Santa Ana River Wasteload Allocation Model Update

BASIN MONITORING PROGRAM TASK FORCE

November 16, 2017

Response to Comments on TM No. 1

Location of Rising Water

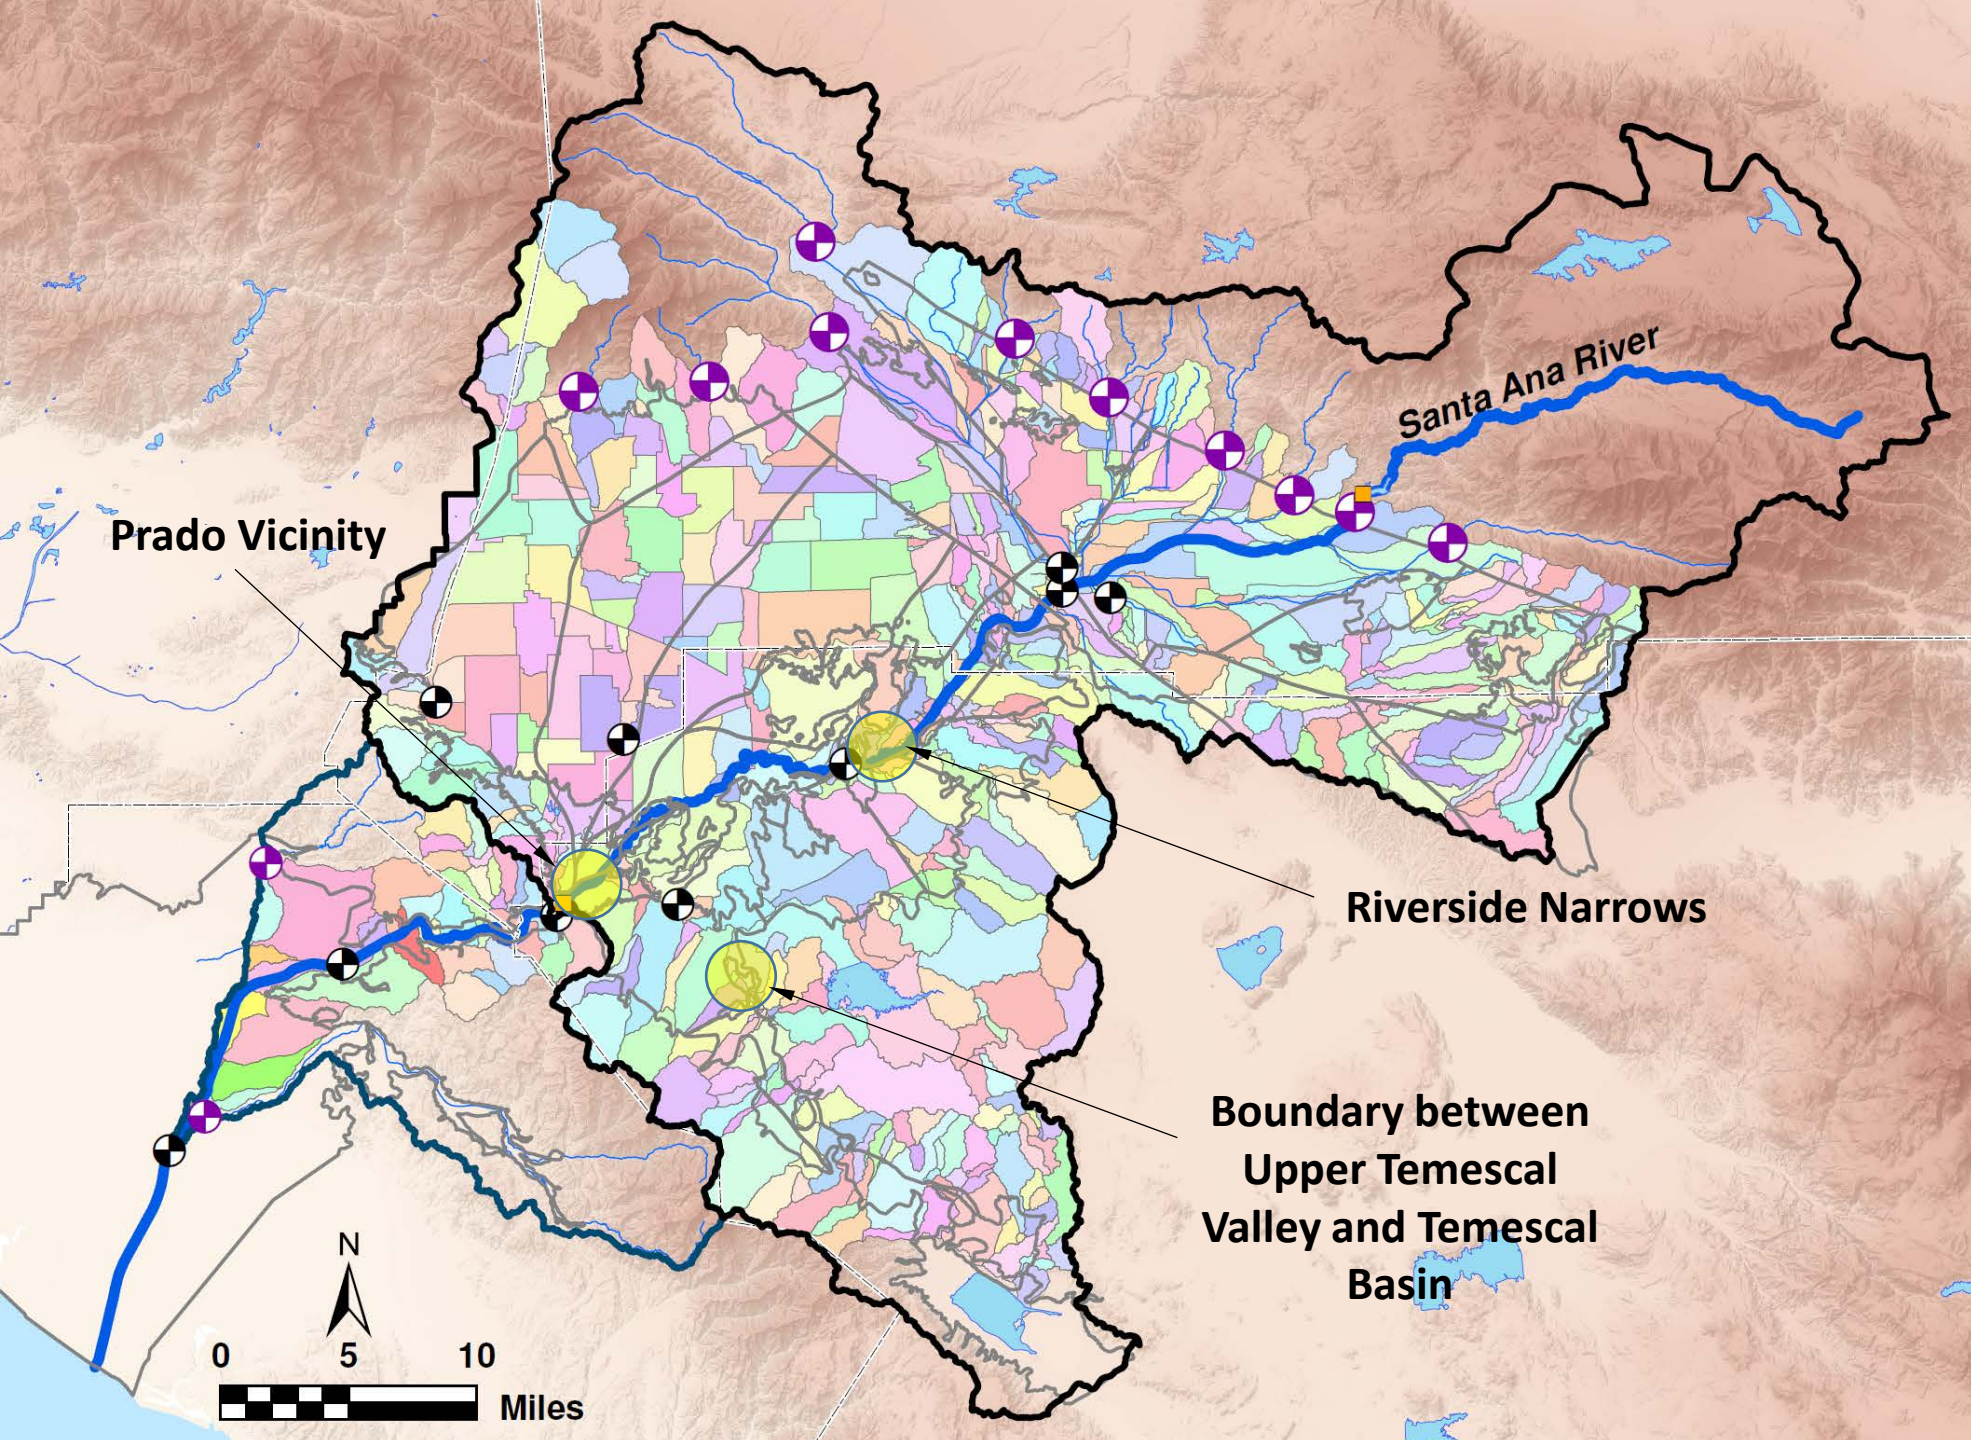
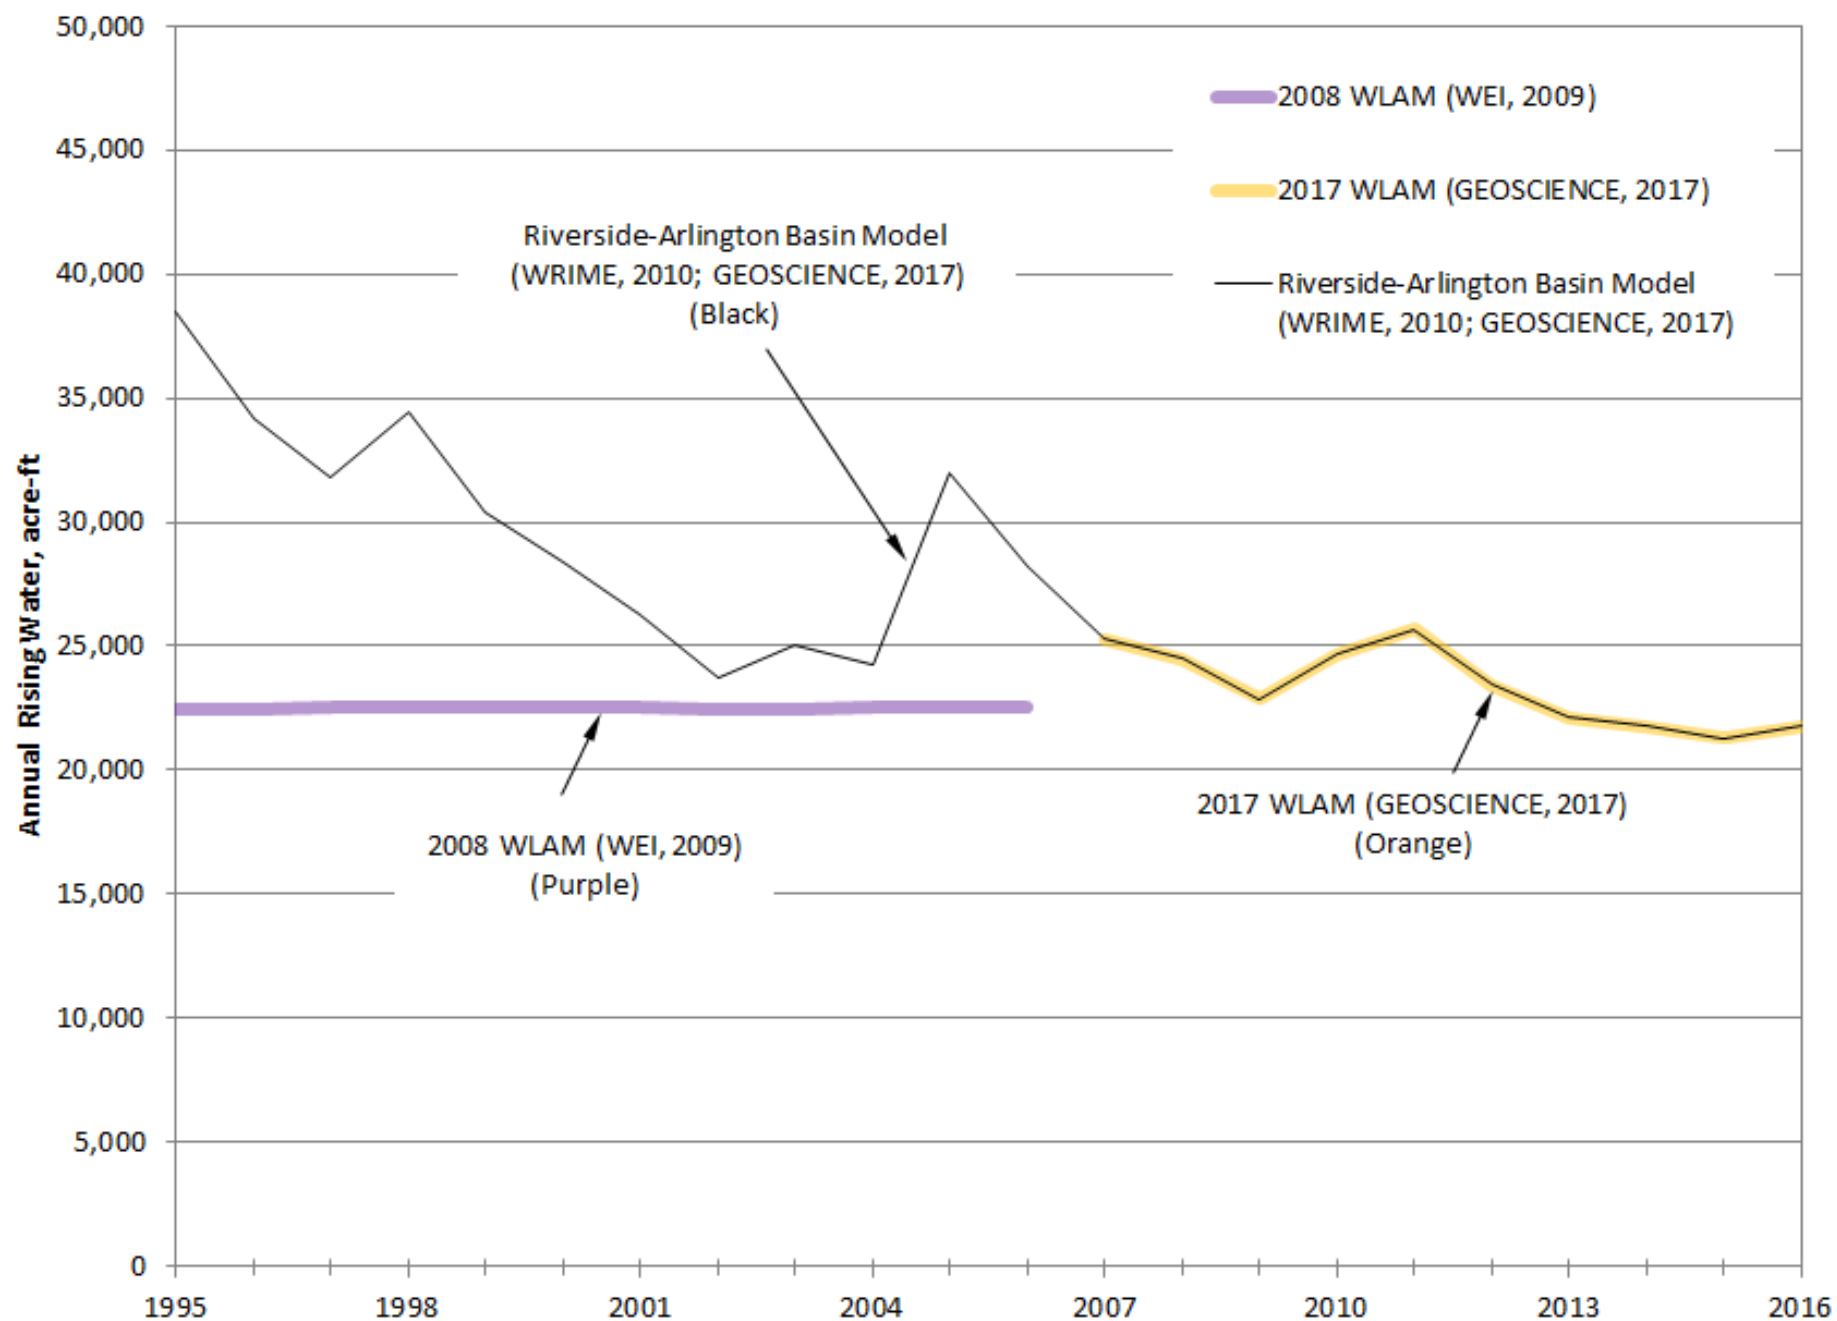
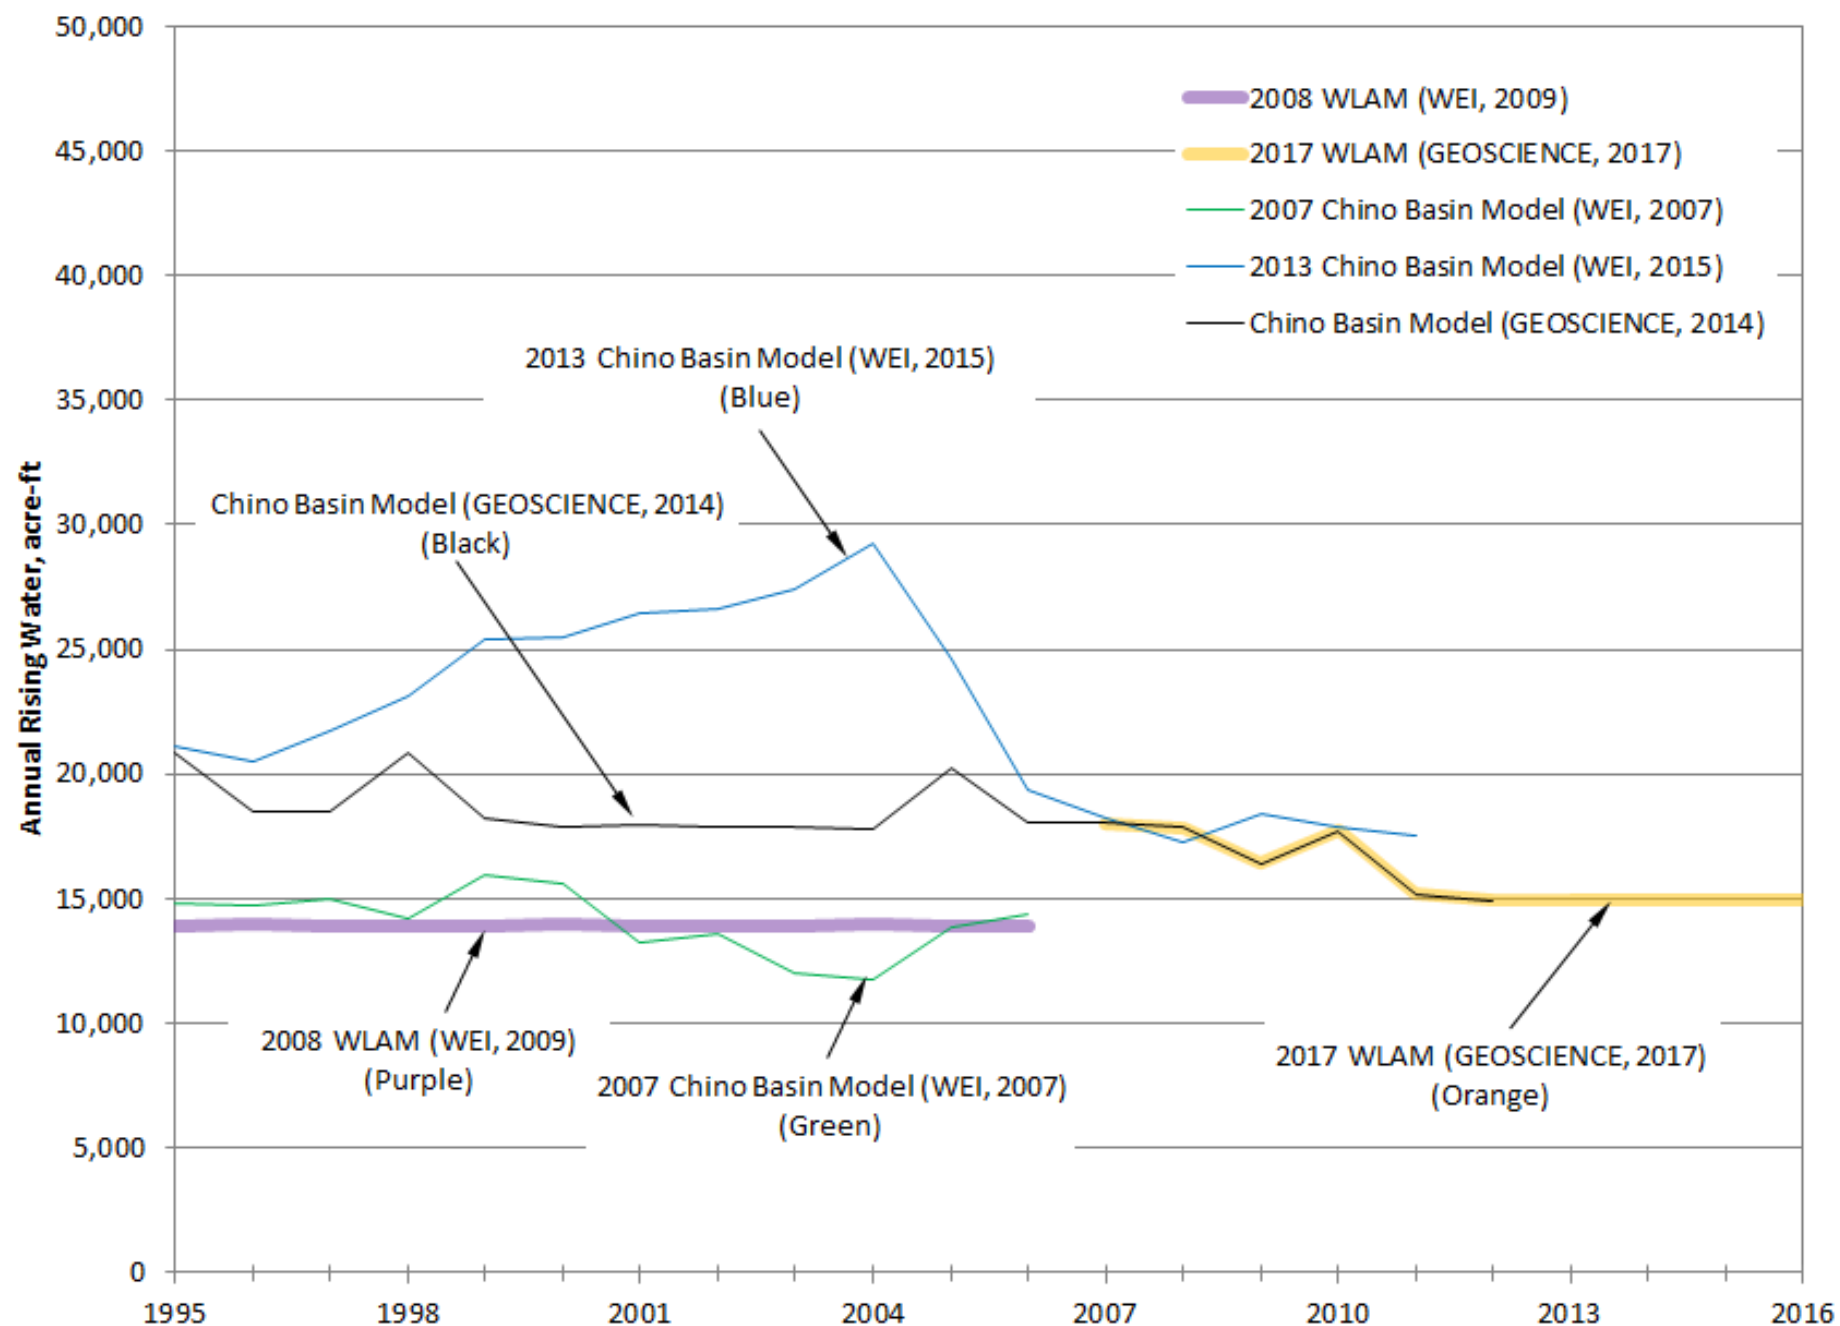
No.	Section	Pg.	Comment	GEOSCIENCE Response
6	2.3.9	10	Section 2.3.9, Rising Groundwater – text should be added to describing how the rising groundwater rate was estimated at the two locations; reference is made in the text to Figure 10, but it is not clear from Figure 10 where the rising groundwater is specified; please include additional features on Figure 10 to specify where rising groundwater is defined in the model;	Explanation will be added.
